**NOTICE OF  
REGULAR MEETING OF THE PLANNING AND ZONING COMMISSION  
HICKORY CREEK TOWN HALL  
1075 RONALD REAGAN AVENUE, HICKORY CREEK, TEXAS 75065  
TUESDAY, FEBRUARY 17, 2026, 6:00 PM**

Project Name: 104 Carlisle – Hickory Creek Addition

**Re: 104 Carlisle Drive (Lot 1, Block A – Hickory Creek Addition)  
Site Plan and Landscape Plan  
3<sup>rd</sup> Review**

Halff received a request from the Town of Hickory Creek to review a Preliminary Plat, Site Plan and Landscape Plan application for 104 Carlisle Drive, Lot 1, Block A Hickory Creek Addition on September 29, 2025. The surveyor is Eagle Surveying, LLC and the engineer is KJE. The owner is Blackbear Durco, LLC.

SITE PLAN

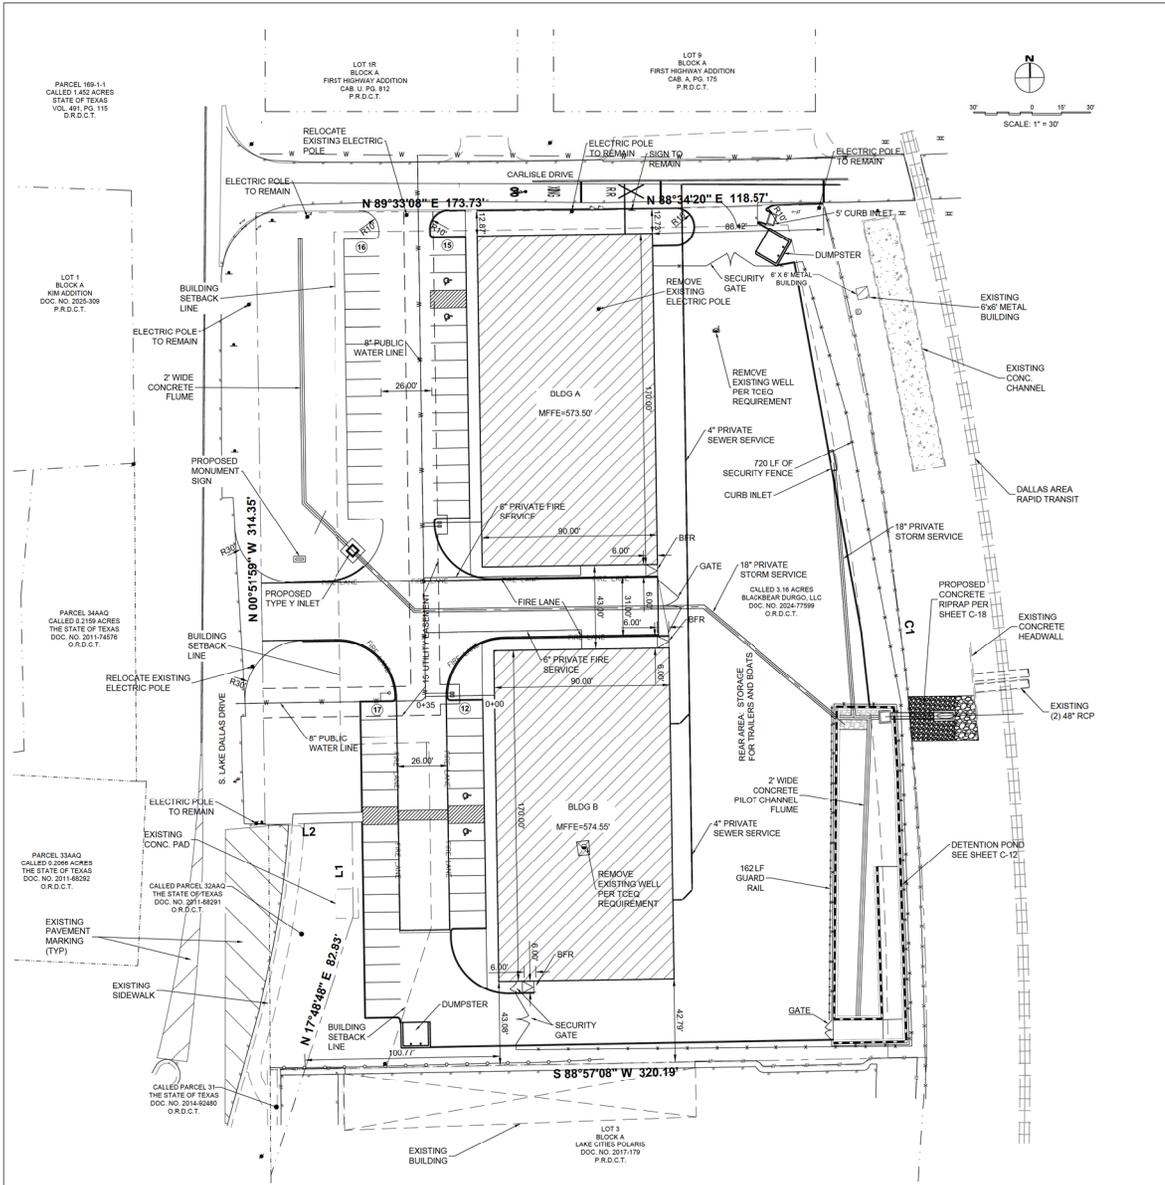
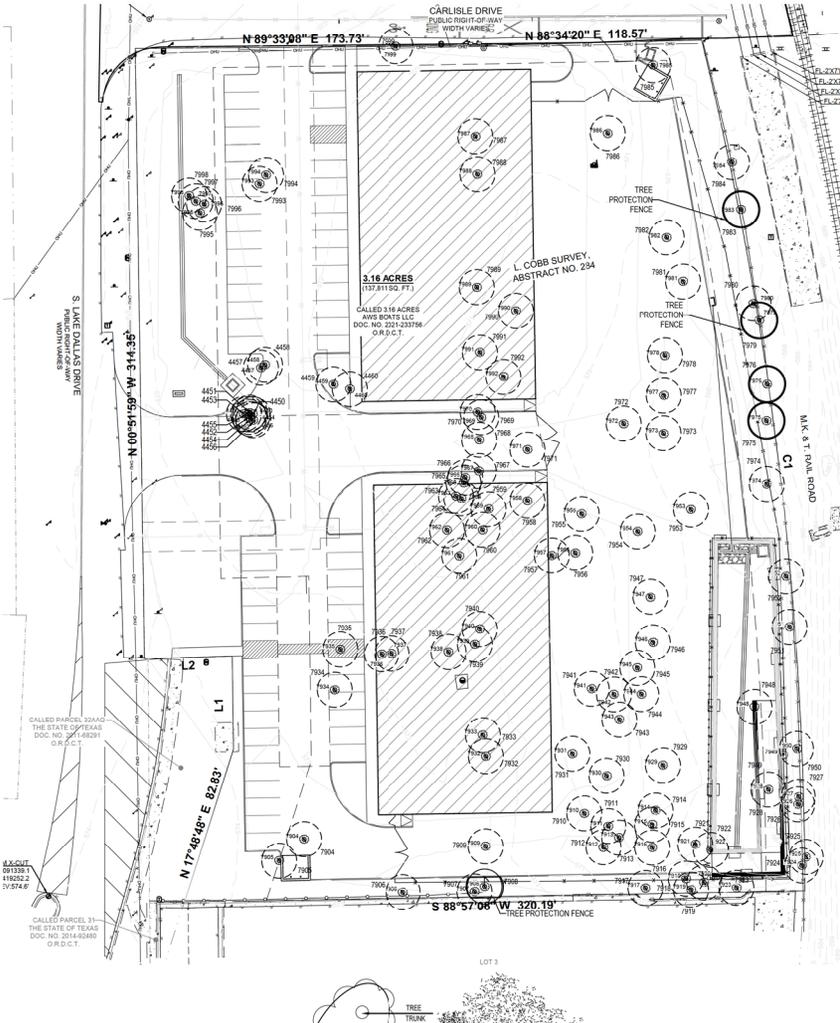
1. Please include the addition name, lot and block numbers, area in acreage, survey name and abstract number, and county in the title block.  
1<sup>st</sup> Review Response: Noted  
2<sup>nd</sup> Review: Comment Not Addressed, Title block has not been updated.  
2<sup>nd</sup> Review Response: Title block has been updated with the addition name, block numbers, area in acreage, survey name and abstract number.  
3<sup>rd</sup> Review: Comment Partially Addressed. Title block still missing addition name and lot/block numbering (See Markups)

2. Please label and dimension all barrier-free ramps on the site plan.  
1<sup>st</sup> Review Response: Noted  
2<sup>nd</sup> Review: Comment Not Addressed. No visible ramps have been labeled or dimensioned.  
2<sup>nd</sup> Review Response: All barrier-free ramps have been labeled with “BFR” and dimensions have been provided for all three barrier-free ramps on site.  
3<sup>rd</sup> Review: Comment addressed.

3. Please confirm intent/show any exterior lighting/pole locations that are proposed.  
1<sup>st</sup> Review Response: Noted  
2<sup>nd</sup> Review: No exterior lighting shown. Existing power pole locations shown.  
2<sup>nd</sup> Review Response: Photometric plan is not prepared at this time. No proposed light poles will be added to this site. All lighting will be on the buildings.  
3<sup>rd</sup> Review: Comment addressed.

4. Please show and label existing and proposed water and sanitary sewer on-site and abutting the property.  
1<sup>st</sup> Review Response: Noted  
2<sup>nd</sup> Review: Comment Not Addressed, no existing or proposed utilities are shown.  
2<sup>nd</sup> Review Response: Proposed water and sanitary sewer are now shown and labeled on the site plan.  
3<sup>rd</sup> Review: Comment mostly addressed. Label existing sanitary sewer main in Carlisle (See Markups)

5. Please show and label existing and proposed storm drain and inlets on the Site Plan.  
1<sup>st</sup> Review Response: Noted  
2<sup>nd</sup> Review: Comment Not Addressed. No existing storm drain shown. Some proposed drainage flumes and storm inlets shown. Not all storm inlets labeled.  
2<sup>nd</sup> Review Response: Existing and proposed storm drain and inlets are now shown and labeled on the site plan.  
3<sup>rd</sup> Review: Comment addressed.

6. Per Note 1 on the Site Plan, please call out the building heights within this note or on site plan.  
1<sup>st</sup> Review Response: Noted  
2<sup>nd</sup> Review: Comment Not Addressed. No change to note.  
2<sup>nd</sup> Review Response: The note has been adjusted to show the building height as 36 feet.  
3<sup>rd</sup> Review: Comment addressed.

7. Per Note 2 on the Site Plan, the assumption made in the note is unlikely to be the case due to ongoing RR coordination and LCMUA improvements proposed to occur within Carlisle Drive that have not yet been finalized for construction. Please consider this and adjust plans accordingly.

8. Add FEMA floodplain note from the plat.

11. Please add a Vicinity Map to the Site Plan.

12. Please callout the dumpster screening wall height and material on the Site Plan.

13. Please add county recording information for the subject property and for all adjacent properties.

15. Please dimension the distance between the buildings on the site plan.

16. Please revise the railroad callout to be DCTA Railway.

1<sup>st</sup> Review Response: Noted

2<sup>nd</sup> Review: Comment Not Addressed. No change in infrastructure layout nor update to the note.

2<sup>nd</sup> Review Response: The note has been removed and we are assuming that Carlisle Drive improvements won't be completed when the site is built.

3<sup>rd</sup> Review: Comment addressed.

1<sup>st</sup> Review Response: Noted

2<sup>nd</sup> Review: Comment Not Addressed. Note not added.

2<sup>nd</sup> Review Response: The note has been added.

3<sup>rd</sup> Review: Comment addressed.

1<sup>st</sup> Review Response: Noted

2<sup>nd</sup> Review: Comment Not Addressed. Vicinity Map not included.

2<sup>nd</sup> Review Response: Vicinity map is now included on the site plan.

3<sup>rd</sup> Review: Comment addressed.

1<sup>st</sup> Review Response: Dumpster is now shown with wall material and heights.

2<sup>nd</sup> Review: Comment Addressed. Dumpster and Wall heights included.

1<sup>st</sup> Review Response: Surrounding properties have been labeled.

2<sup>nd</sup> Review: Comment Not Addressed. Missing information on adjacent and subject lots.

2<sup>nd</sup> Review Response: Information on all adjacent lots are provided.

3<sup>rd</sup> Review: Comment addressed.

SHEET NAME:  
 TREE PRESERVATION PLAN

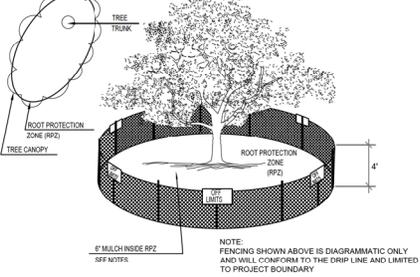
18. The evaluation on “Health” of the trees will need to be confirmed, signed or declared by an ISA Certified Arborist in order to qualify for exemption on mitigation inches for these trees deemed unhealthy, per Zoning Ordinance Section 10.02.004 Item h.4.A. This tree preservation plan sheet must bear the certified Arborist name and their ISA Certification number for confirmation.

19. Please verify the calculated tree mitigation inches required per the markups.

1<sup>st</sup> Review Response: Plan sheet bears the ISA Cert number and arborist name that evaluated the information.

2<sup>nd</sup> Review: Comment Addressed.

1<sup>st</sup> Review Response: This has been adjusted to 554 caliper inches.

2<sup>nd</sup> Review: Comment Addressed

SHEET NAME:  
LANDSCAPE PLAN

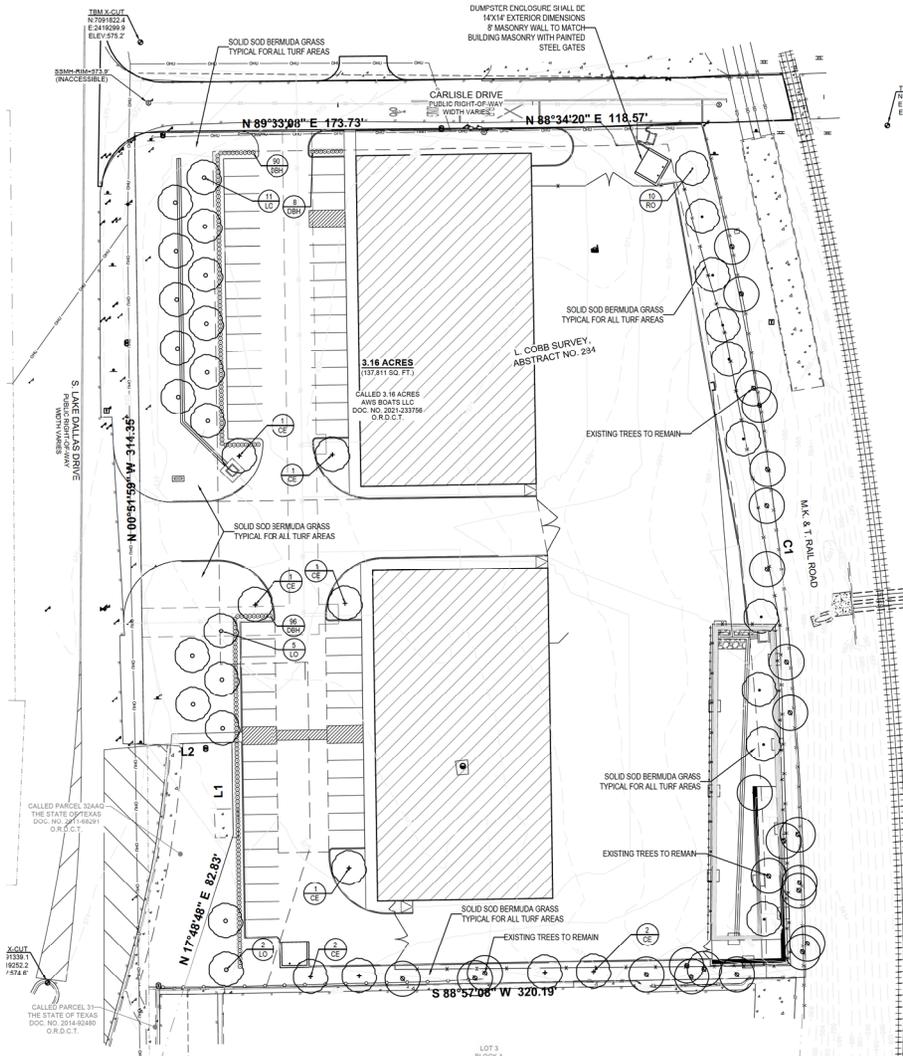
20. Please show the dumpster screening wall materials and height on the landscape plan.

21. Verify landscape tabulations shown for tree credits, provided inches, parking spaces, and total trees provided. (See Markups)

22. Plans show planting of 37 trees at 3-inch caliper equaling 111 mitigation inches provided. Total mitigation inches required is 530 inches. Please confirm intent on the remaining 419 mitigation inches and if meant to be covered/paid in fee.

1<sup>st</sup> Review Response: Dumpster is now shown with wall material and heights.

2<sup>nd</sup> Review: Comment Addressed

1<sup>st</sup> Review Response: Changed to 34 tree credits. Changed to 37 trees. The amount of parking has remained the same.

2<sup>nd</sup> Review: Comment Partially Addressed. Should show 28 tree credits to match revised calculation from previous sheet. All other revisions addressed.

1<sup>st</sup> Review Response: The above note has been adjusted to show that the total mitigation fee is accounting for 443 total trees.

2<sup>nd</sup> Review: Comment Addressed. **Remaining 443 mitigation inches are to be paid for in fee.**
